### **SUB15-00064 / Millwell Place Subdivision**

Preliminary plat for a residential subdivision comprised of 68 buildable and 2 common lots on 17.97 acres located at 6512 W. Saxton Avenue in an R-1C (Single Family Residential) zone.

**PRELIMINARY PLAN FOR MILLWELL PLACE SUBDIVISION**

## Planning Division Project Report

**SITE LAYOUT PLAN**

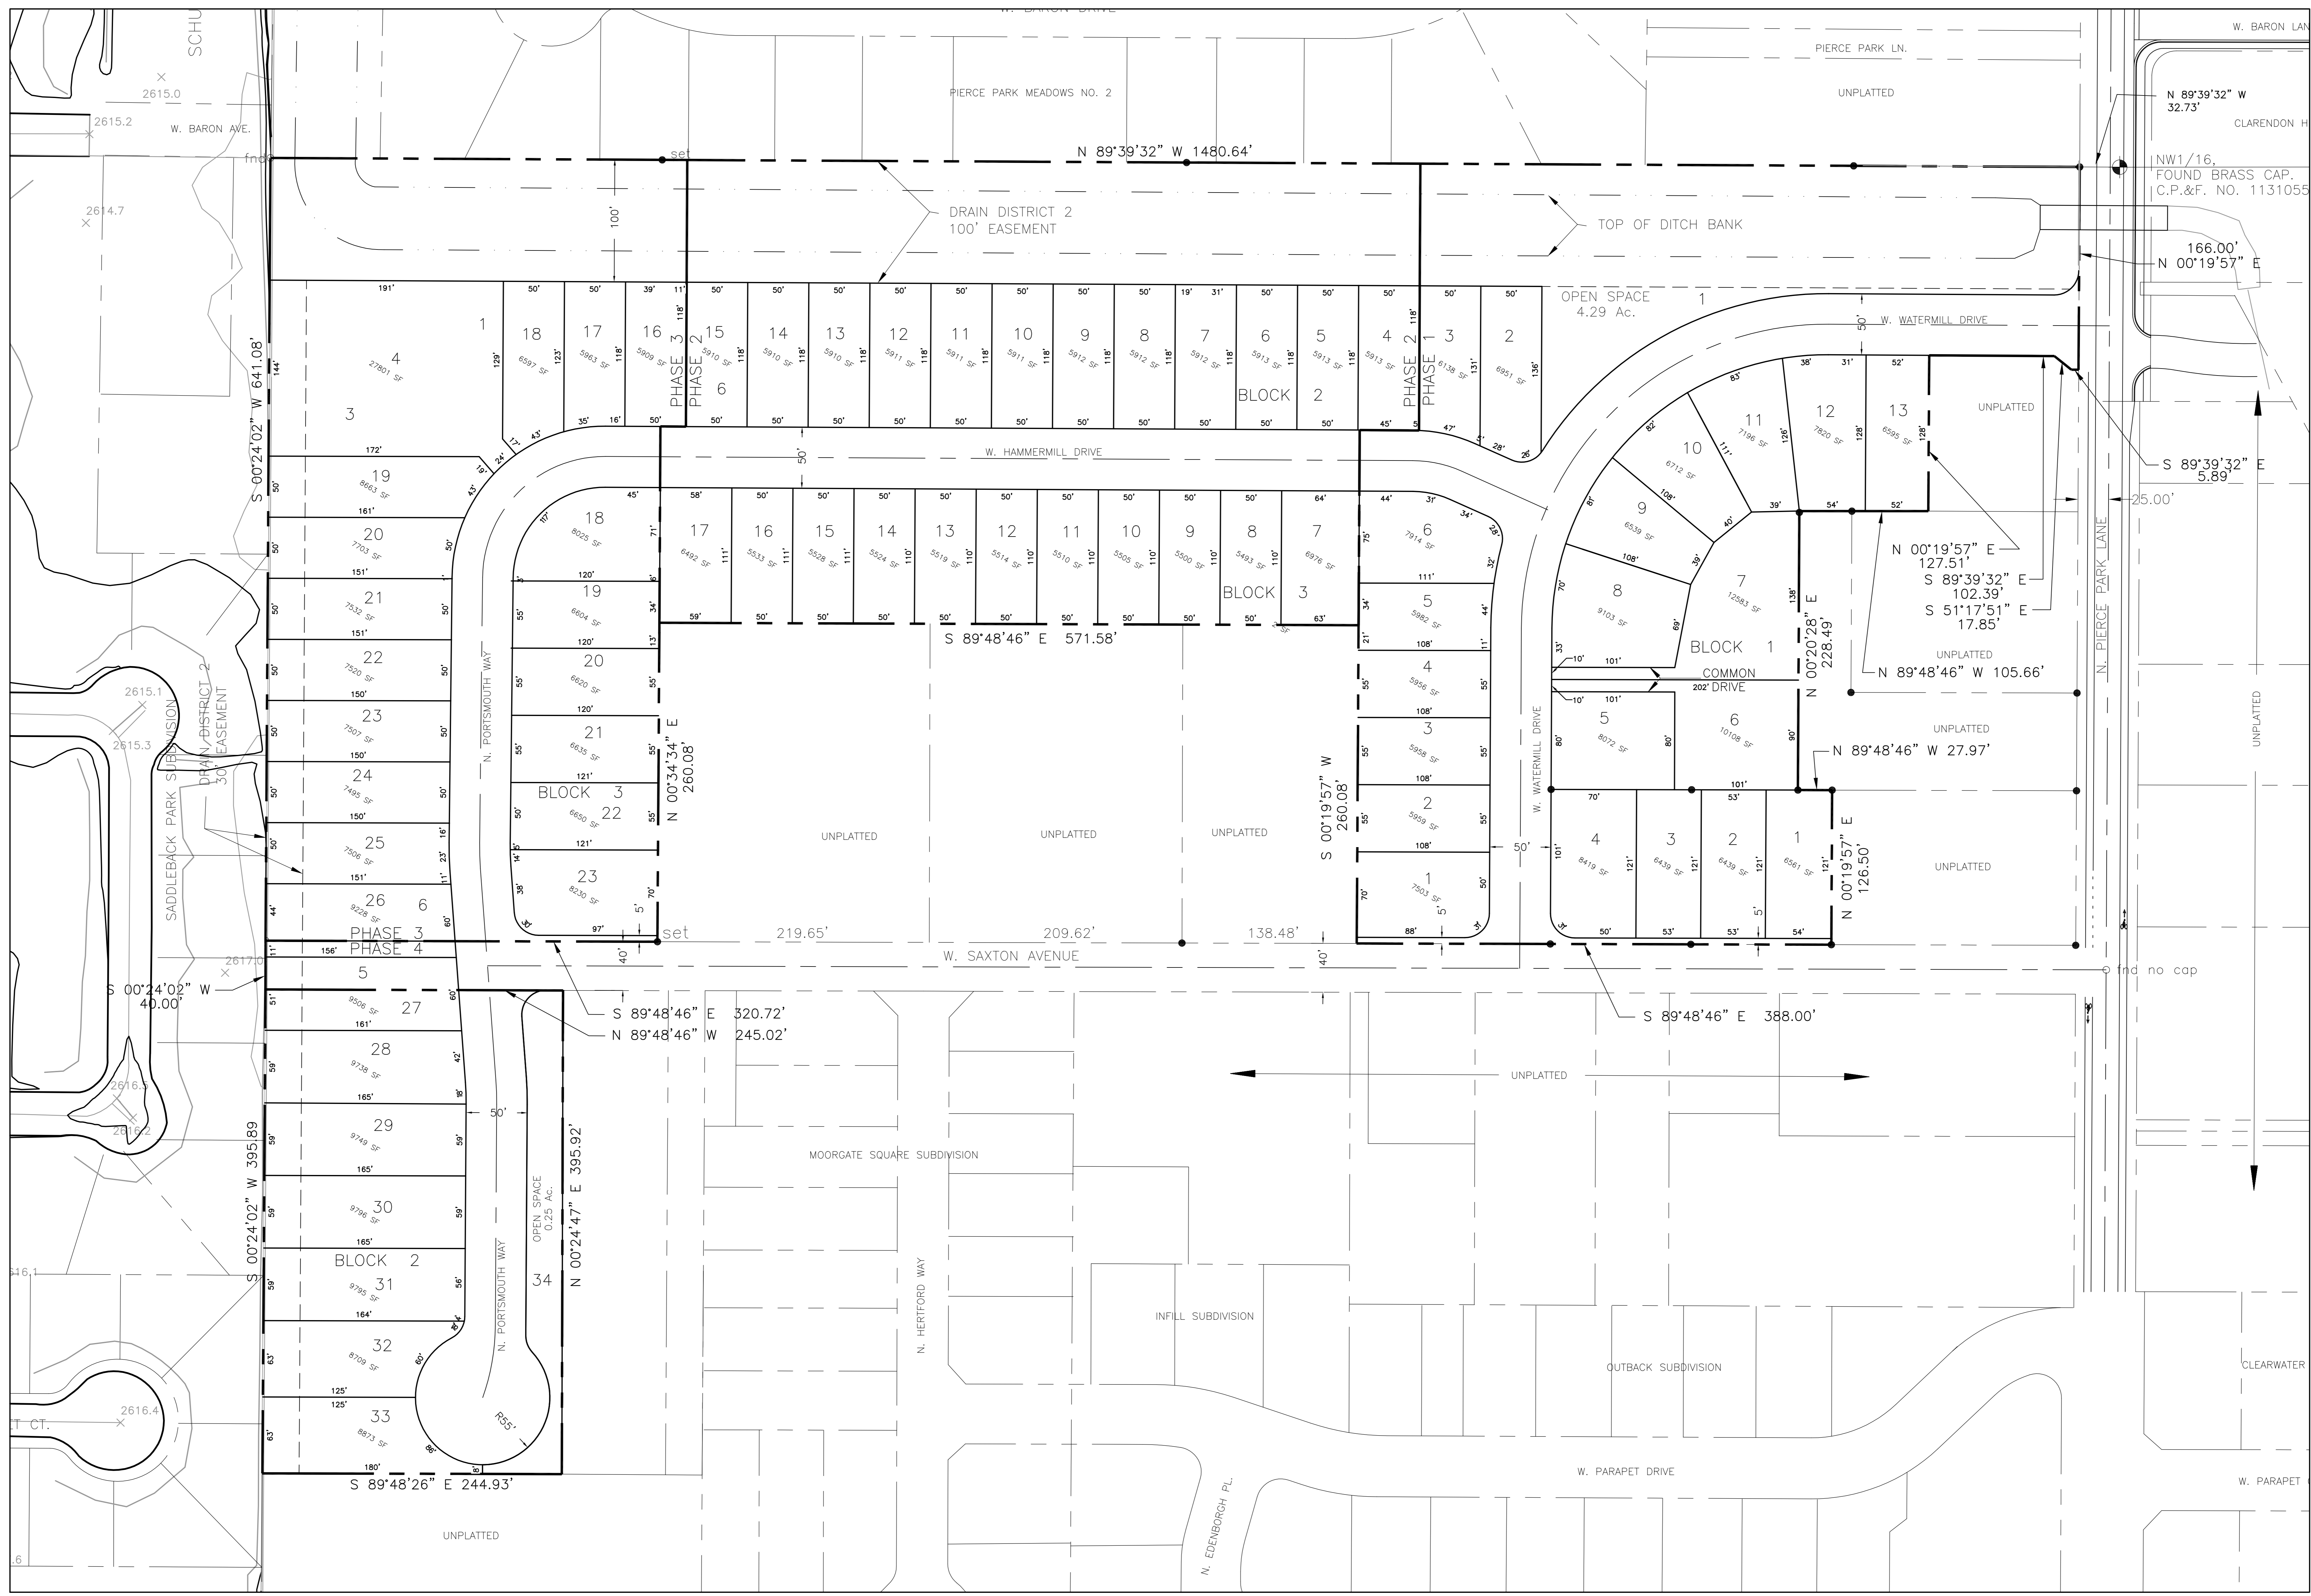
- b. The common driveways for Lots 5-8, Block 1 shall comply with the requirements of section 11-07-02 (C) of the Development Code.
- c. Prior to approval of the Final Plat, the Record of Survey (ROS15-00108) shall be recorded.

- d. A stub-street connection shall be provided from the terminus of Hammermill Drive to the 2.22 acre parcel immediately to the south.
- e. Pierce Park Lane and Saxton Avenue as they abut the property shall be improved with a minimum five foot wide detached sidewalk with an 8 foot wide landscape strip.

- x. Correct street names as approved by the **Ada County Street Name Committee** shall be placed on the plat (B.C.C 9-06-05.M) per comments dated December 10, 2015.

**SITE GRADING, DRAINAGE AND UTILITY PLAN**

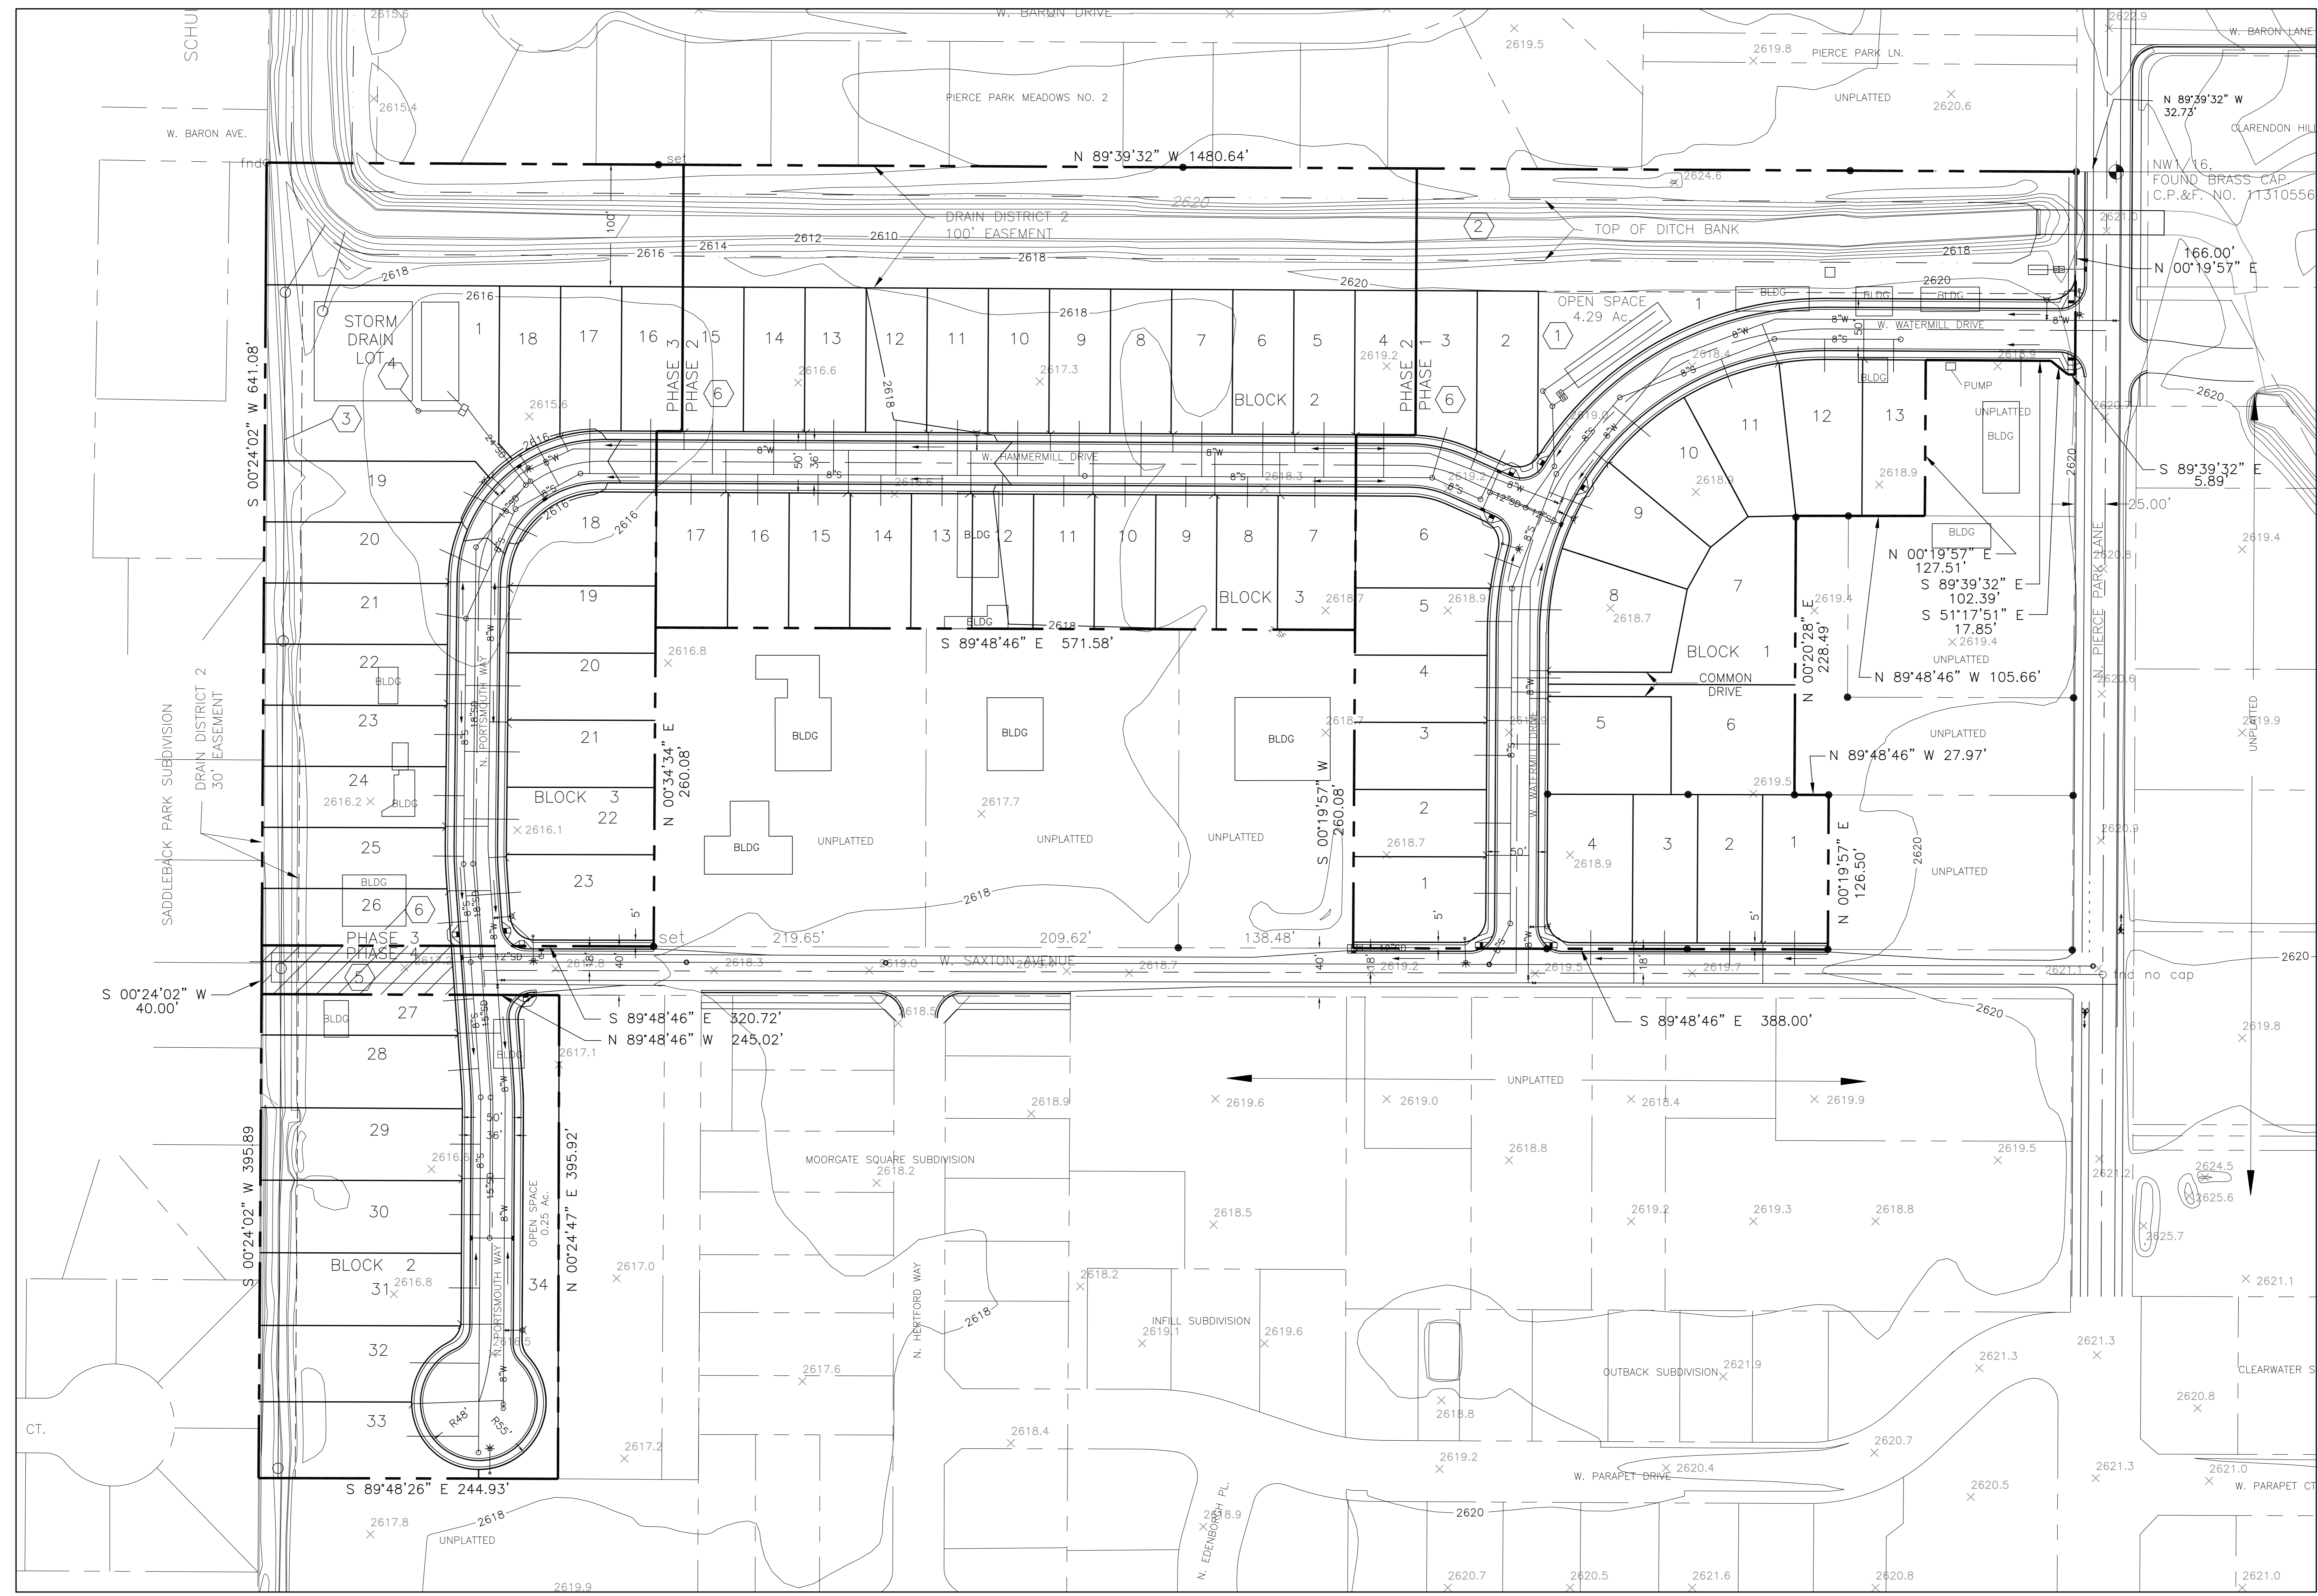
- t. The applicant shall comply with the requirements of the **Boise City Public Works Department** (BCPW) for:
1. Municipal sewer in a memo dated December 1, 2015.

2. Street lighting in a memo dated December 1, 2015.
  3. Pressurized irrigation in a memo dated December 1, 2015.
  4. Drainage in a memo dated December 1, 2015.
